## Service Bulletin 57, (A)

**Subject:** Aileron Crossover Cable Lengths

**Applicability:** All Sportsman Kits

**Issue:** Revised Cable Lengths

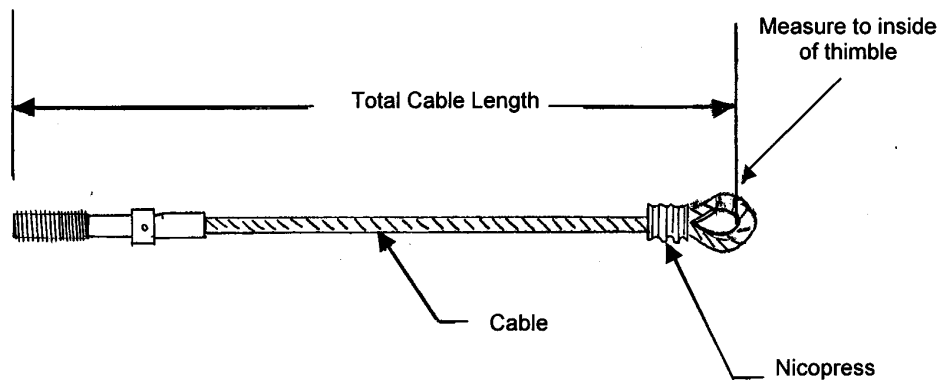
Note: The shackle shown in the figure in Service Bulletin 57 has been eliminated in simplifying the procedure of measuring and fabricating the cable ends. It has not been eliminated in the cable installation!

Part Number	Cable Position	Total Length	Revised Length
618-01014-01	LH Aileron Crossover Cable	<del>140 1/4"</del>	139 3/4"
618-01015-01	RH Aileron Crossover Cable	<del>155 13/16"</del>	155 3/8"
618-01013-01	LH Aileron Secondary Cable	<del>176 3/4"</del>	175 1/2"
618-01013-01	RH Aileron Secondary Cable	<del>176 1/8"</del>	175 3/4"
